Model: S-P2 Duplex unit		Date: 22-Feb-10	No.: RG893001
Subject: Duplex jam		Prepared by: Y. Murata	
From: 2nd Overseas Tech. Support Sec., 2nd PQM Dept.			
Classification:	<input checked="" type="checkbox"/> Troubleshooting <input type="checkbox"/> Mechanical <input checked="" type="checkbox"/> Paper path <input type="checkbox"/> Other ()	<input checked="" type="checkbox"/> Part information <input type="checkbox"/> Electrical <input type="checkbox"/> Transmit/receive	<input type="checkbox"/> Action required <input type="checkbox"/> Service manual revision <input type="checkbox"/> Retrofit information <input checked="" type="checkbox"/> Tier2

Model: S-P1/P2		Date: 10-Dec-15	No.: RG893002
Subject: Parts Catalog Correction – Front and Rear Side Plate p/n		Prepared by: R.Tsurumi	
From: 1st Tech. Support Sec. Service Support Dept.			
Classification:	<input type="checkbox"/> Troubleshooting <input checked="" type="checkbox"/> Part information <input type="checkbox"/> Action required <input type="checkbox"/> Mechanical <input type="checkbox"/> Electrical <input type="checkbox"/> Service manual revision <input type="checkbox"/> Paper path <input type="checkbox"/> Transmit/receive <input t

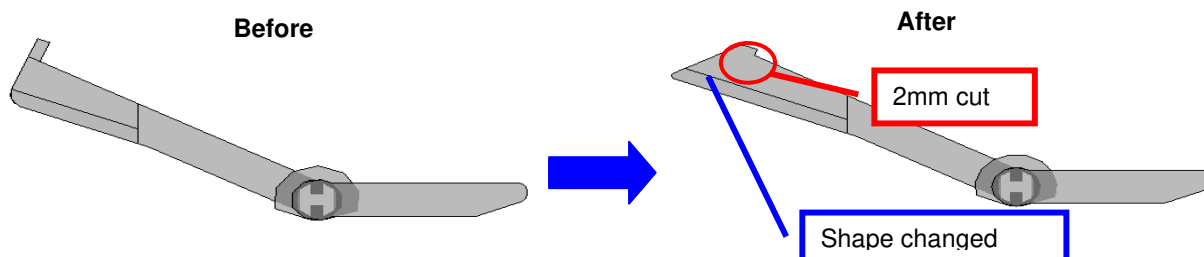
After jammed paper is removed following a misfeed, the “Remove Misfeed Duplex Unit” display does not clear.

The sensor feeler sometimes contacts the inside of the machine frame, damaging the feeler. This can happen if the operator lifts up the unit while pulling it out, or if a Z-fold jam has occurred.

The shape of the feeler was changed so that it does not contact the frame in such cases.

G3612810

G8932810
